EXPLANATION OF SIGNIFICANT DIFFERENCES

ST. MARIES CREOSOTE SITE

ST. MARIES, IDAHO

FEBRUARY 2014

ROD-BASED REMOVAL DELINEATION

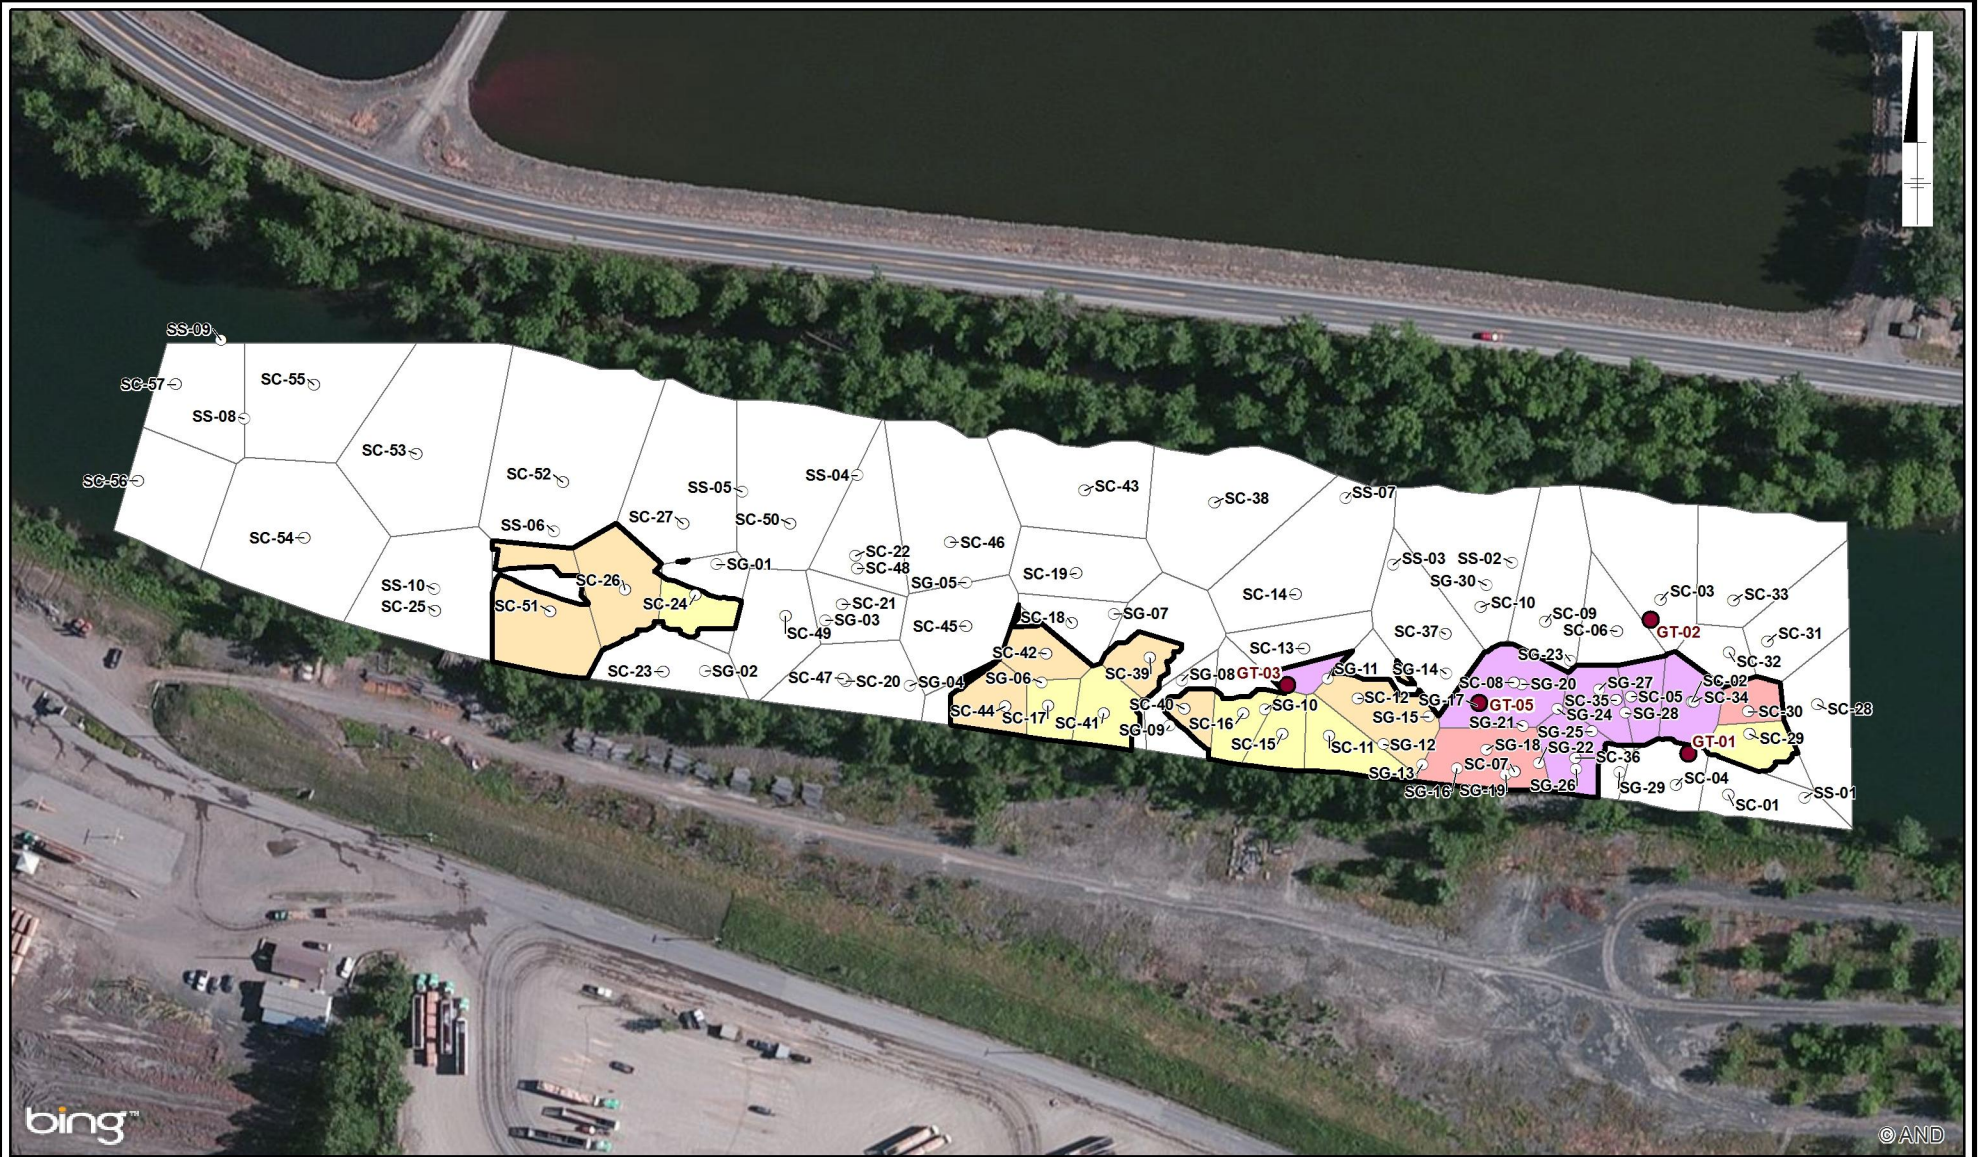
The ROD provides cleanup levels (in Table 25) for 16 individual chemicals and 2 chemical groups called low-molecular weight PAHs (LPAHs) and high-molecular weight PAHs (HPAHs). The ROD requires sediment that fails any one of the cleanup levels to be dredged from the river. The ROD also estimated that 16,978 cubic yards (cy) of sediment would need to be dredged. However, the ROD acknowledged that a large area of sediment had yet to be characterized. Additional characterization has been completed that shows a much larger area of sediment contamination than assumed in the ROD. Contamination extends deeper into the sediment and is found farther downstream than anticipated. Based on the cleanup levels in the ROD and the additional sediment sampling conducted, an estimated 41,188 cy of sediment would be required to be dredged. This revised volume is almost two and a half times the volume presented in the ROD. The map showing the delineated area based on the ROD cleanup levels is provided in Figure 2.
